Amendments to the Drawings

Applicants: Benjamin Esposito et al.
Filed: April 9, 2004
Application No.: 10/821,377
For: MAINTAINING DATA INTEGRITY FOR EXTENDED DROP OUTS ACROSS HIGH-SPEED SERIAL LINKS
Agent: Michael J. Chasan - Reg. No. 54,026

EXPRESS MAILING LABEL NO. EV930034254US
Docket No.: 000174-0329-101 (A01393)
Confirmation No.: 1615
Annotated Sheets 1 of 3

FIG. 1
(Prior Art)

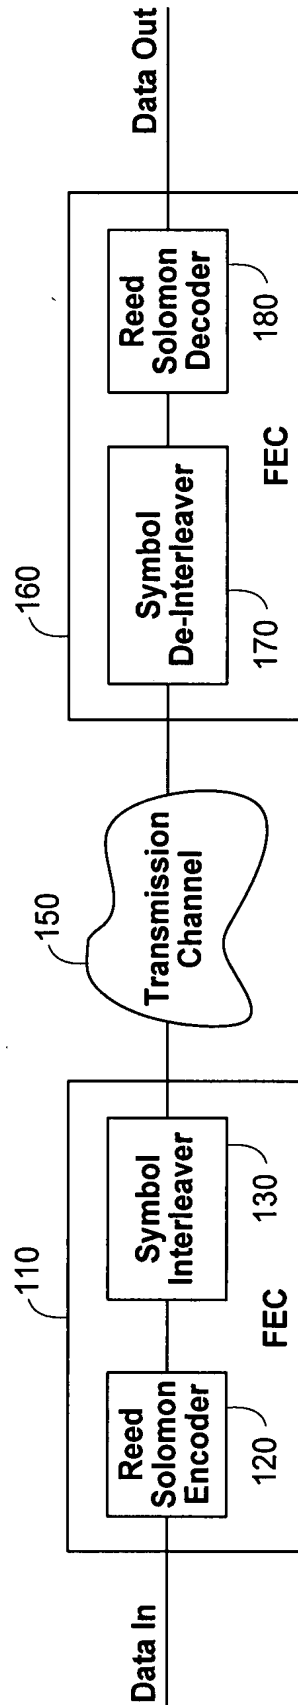
The Examiner objected to FIGS. 1 and 2 for not being designated as "Prior Art."

FIGS. 1 and 2 were objected to for not being designated as "Prior Art." Applicants have amended FIGS. 1 and 2 to insert the "Prior Art" designation. Accordingly, applicants respectfully request that the Examiner's objection to FIGS. 1 and 2 be withdrawn.

FIG. 5

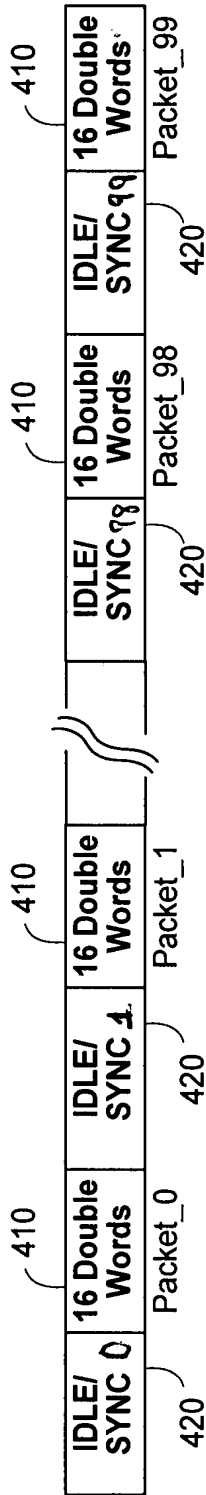
The Examiner also objected to the drawings under 37 C.F.R. § 1.83(a) for not showing every feature of the invention specified in the claims. Specifically, the Examiner objected to the drawings for not showing the "plurality of sequential identification packets."

The drawings were objected to under 37 C.F.R. § 1.83(a) for not showing every feature of the invention specified in the claims. Specifically, the Examiner objected to the drawings for not showing the "plurality of sequential identification packets." Applicants have amended FIG. 5 to insert the sequence numbers of IDLE/SYNC packets 420.
